Subject: East Altamont Energy Center Application for Certification  
Data Request Response Set #2 (01-AFC-04)

**EAST ALTAMONT ENERGY CENTER  
DATA REQUESTS #2  
(01-AFC-4)**

**FIGURE 2.2-2R**  
**PLANT ELEVATION**  
 APPLICATION FOR CERTIFICATION  
 FOR EAST ALTAMONT ENERGY CENTER

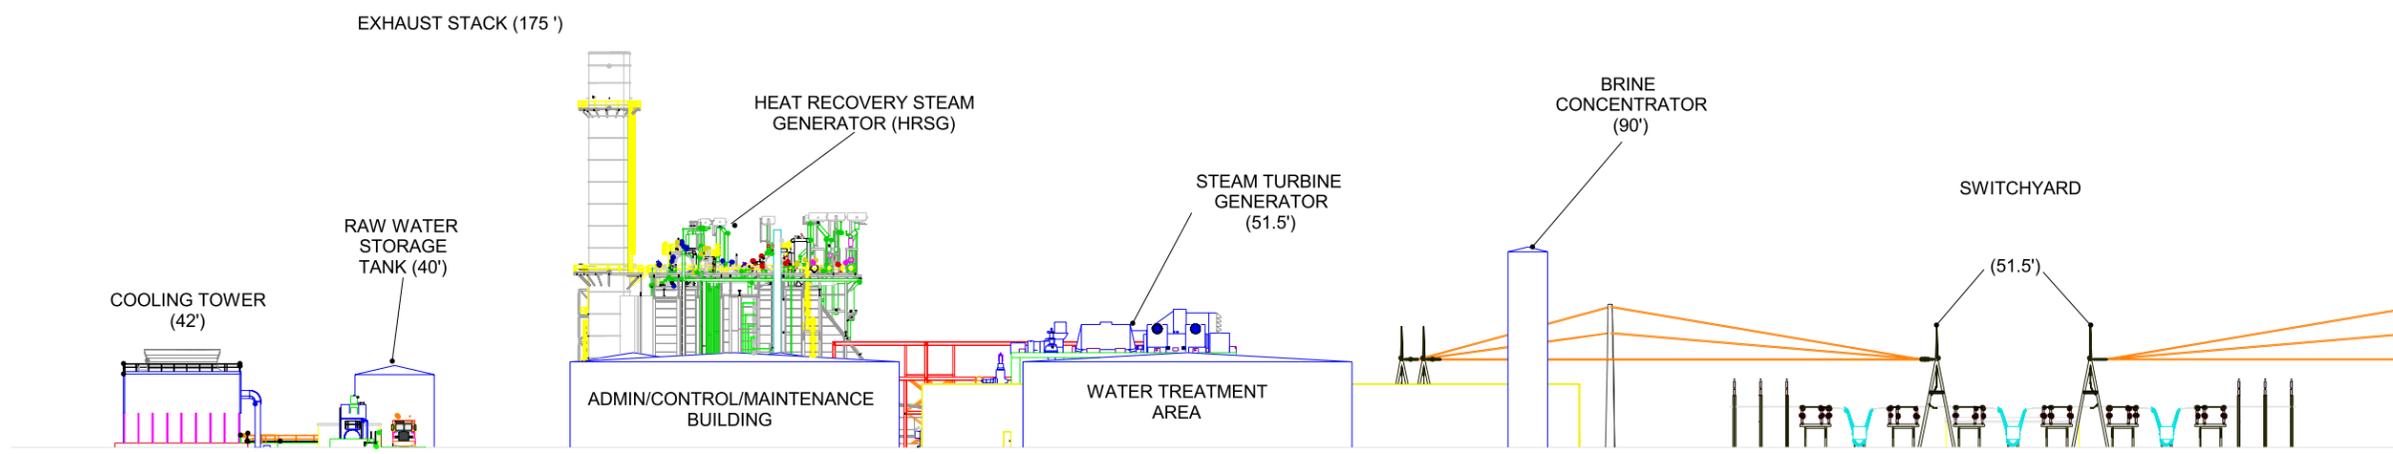
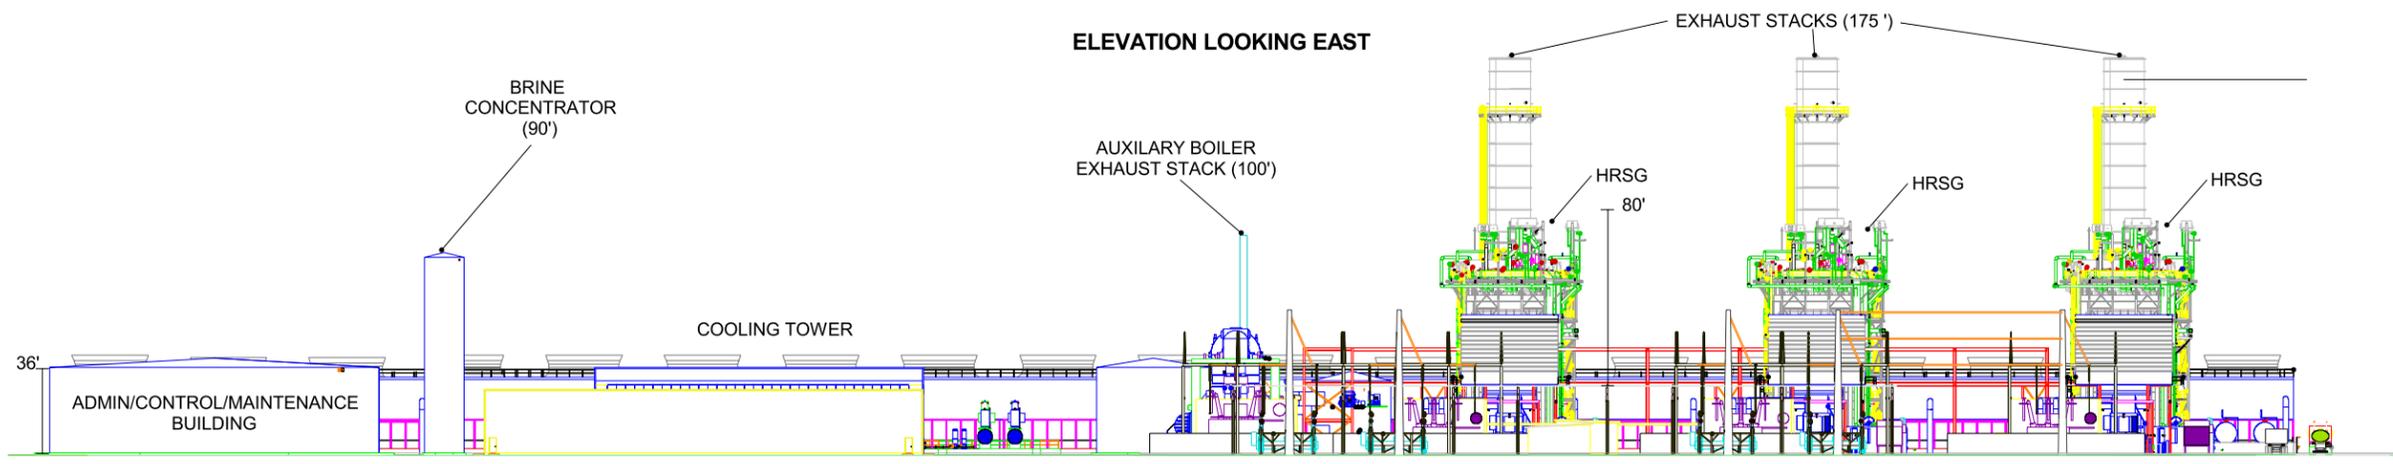
108. In order to facilitate the reader’s understanding of project scale and structural relationships, please revise Figure 2.2.2 to include names and heights of key project components.

**Response:** Figure 2.2-2R presents an elevation drawing of the project and includes names and heights of key project components.
